**DEVIATION REQUEST
AND DECISION FORM IN
ASSOCIATION WITH A
REQUEST FOR A PUD
MODIFICATION FROM
THE ECM**

Project Name : Waterside
Schedule No.(s) : 71114-04-112
Legal Description : All of the waterside condominiums subdivision, recorded in Plat Book 2, At Page 47 Records of El Paso County, Colorado

A deviation from the standards of or in Section **ECM 2.3.8.A** of the Engineering Criteria Manual (ECM) is requested.

WATERSIDE TOWNHOMES
 DEVIATION REQUEST - ECM SEC. 2.3.8.A.
 PCD FILE NO. PUDSP-22-009

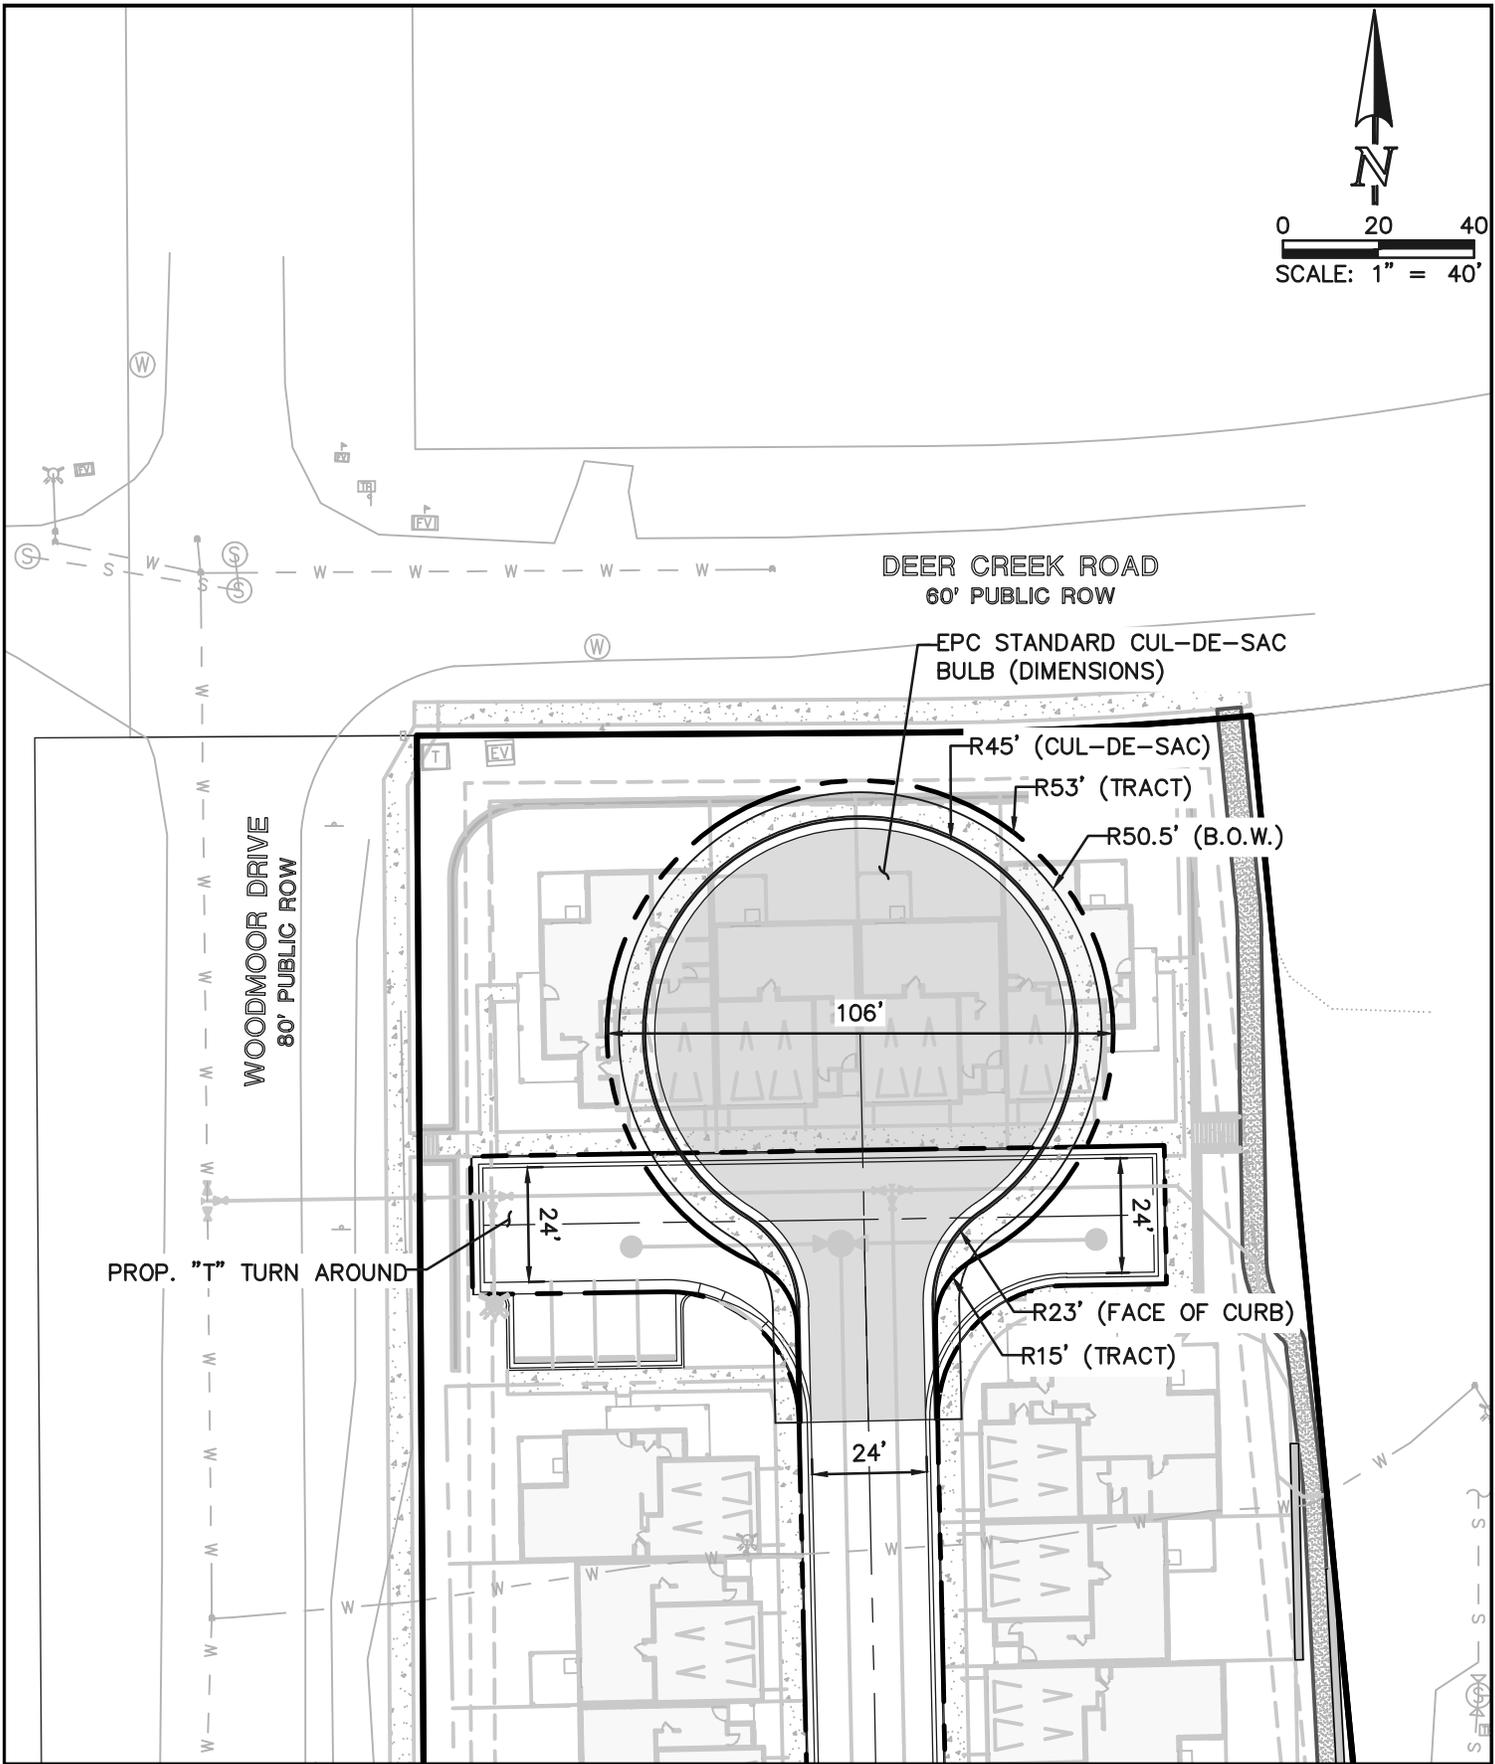
Roadway Terminations – Hammerhead turnarounds are not permitted as permanent roadway terminations.

The unique urban residential community consists of townhomes. While the main community access is from standard public local roadways, the use of the private roadways is limited to closed looped areas that will be signed as being private. A single private hammerhead is proposed for the northerly roadway terminus since access to Deer Creek Road is not allowed. Adequate emergency vehicle backing and maneuvering areas are provided.

The proposed short dead-end stubs (hammerhead turn around) allow the continuations of the community design concept with no adverse impacts to resident maneuverability. Only residents occupying the proposed four (4) townhomes will use the turnaround area to access their garages. Anyone unfamiliar with the site could utilize the private hammerhead to turnaround and exit, if needed, similar to the operational aspects of a cul-de-sac.

The northerly turn around area is proposed due to the limited access spacing along Deer Creek Road (i.e. no access), and the small amount of traffic that would be present within the proposed community. The width of parcel is only slightly larger than the width of a standard cul-de-sac bulb, severely limiting the community use of this area (see attached exhibit).

We have reviewed the attached hammerhead as proposed and approved the modifications.

The Deviation is only valid until and unless the Board of County Commissioners approves the Planned Unit Development Modifications.
